**Proposal #37: 7540-01-72, WISC 2019 759
Fairchild – Black River Falls
Allen Creek B-27-0170
USH 12
Jackson County**

This is Addendum No. 01, which provides for the following:

ADDENDUM NO. 01

Addendum No. 01
ID 7540-01-72
Revised Sheet 79
December 5, 2019

GENERAL PLAN
SHEET 1 OF 17
79

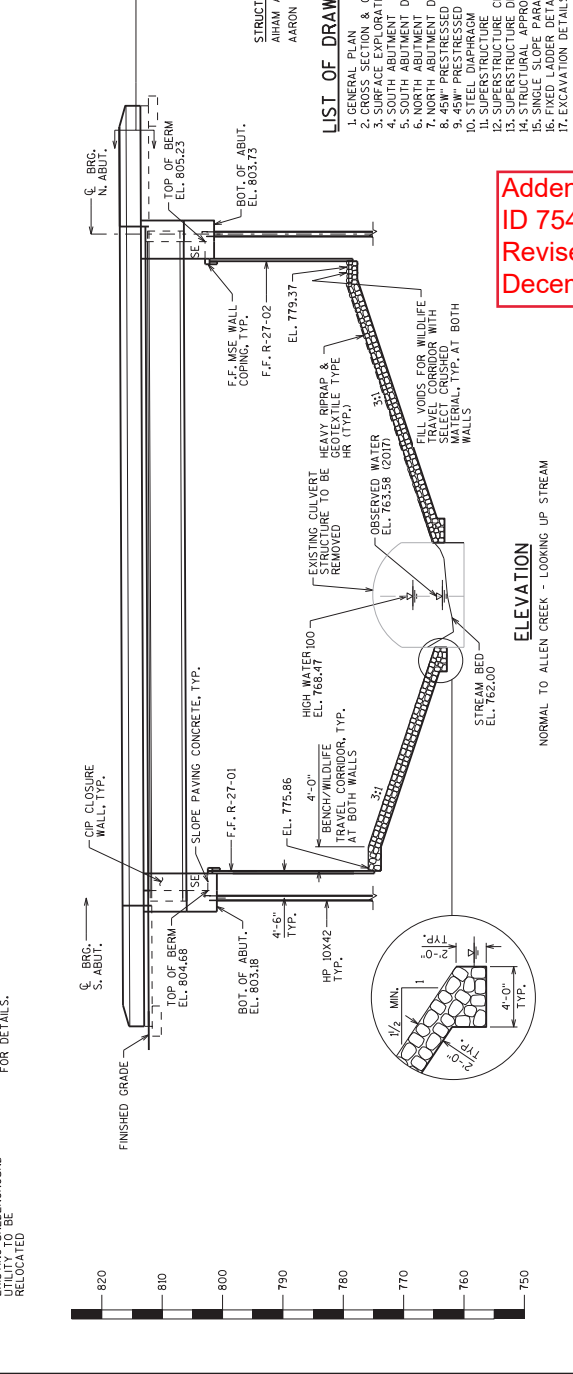
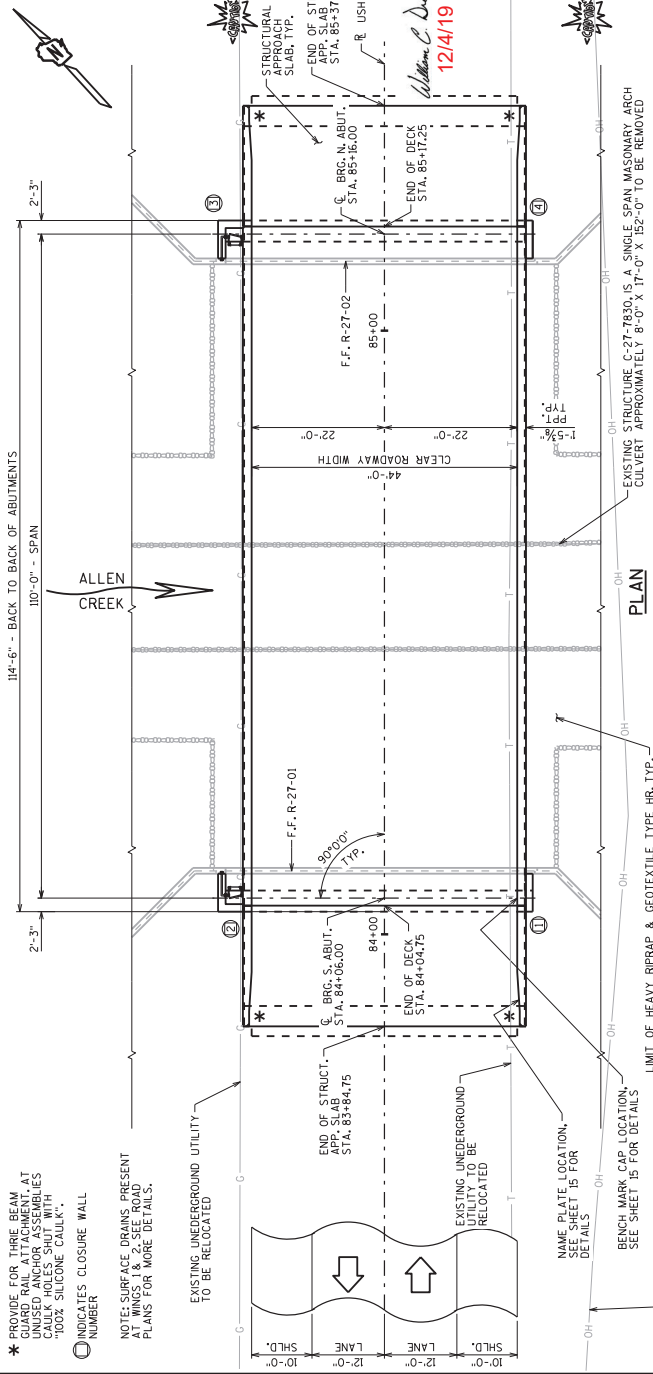
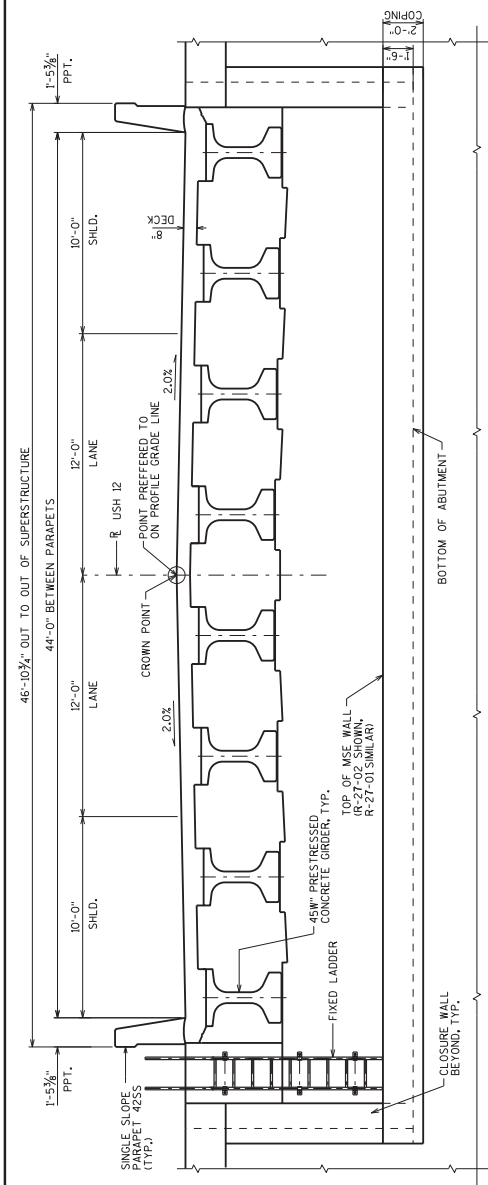
Revised Plan Sheets	
Plan Sheet	Plan Sheet Title (brief description of changes to sheet)
79, 80	Structure B-27-170 (Pre-Boring quantity change)

12/24/19 PRE-BIDDING QUANTITY CHANGE AA
NO. DATE REVISION BY

ABUTMENTS TO BE SUPPORTED ON HP 10 X 42 PILING PREPARED TO A REQUIRED DRIVING RESISTANCE OF 180 TONS ** PER PILE. PILING TO BE DRIVEN TO A MINIMUM OF 10 FEET BELOW ESTIMATED 95 FT. LONG AT BOTH ABUTMENTS. PREBORING ESTIMATED 10" AT EACH PILE AT SOUTH ABUTMENT AND 26" AT ABUTMENTS. MINIMUM OF 10" INTO SOUND BEDROCK. ** THE FACTORED AXIAL RESISTANCE OF PILES IN COMPRESSION USED FOR DESIGN SHALL BE BASED ON THE RESISTANCE FACTOR OF 0.5 USING MODIFIED GATES TO DETERMINE DRIVEN PILE CAPACITY.

CROSS SECTION & QUANTITIES
SHEET 2 OF 80

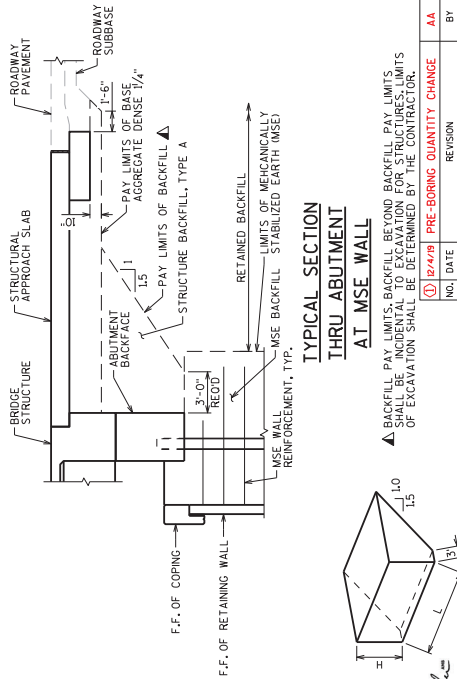
12/24/19 PRE-BORING QUANTITY CHANGE AA

516.0500	RUBBERIZED MEMBRANE WATERPROOFING	SY	---	13	13	26	
550.0020	PRE-BORING ROCK OR CONSOLIDATED MATERIALS	LF	---	110	110	220	
550.1100	PILING STEEL HP 10-INCH X 42 LB	LF	---	605	605	1,210
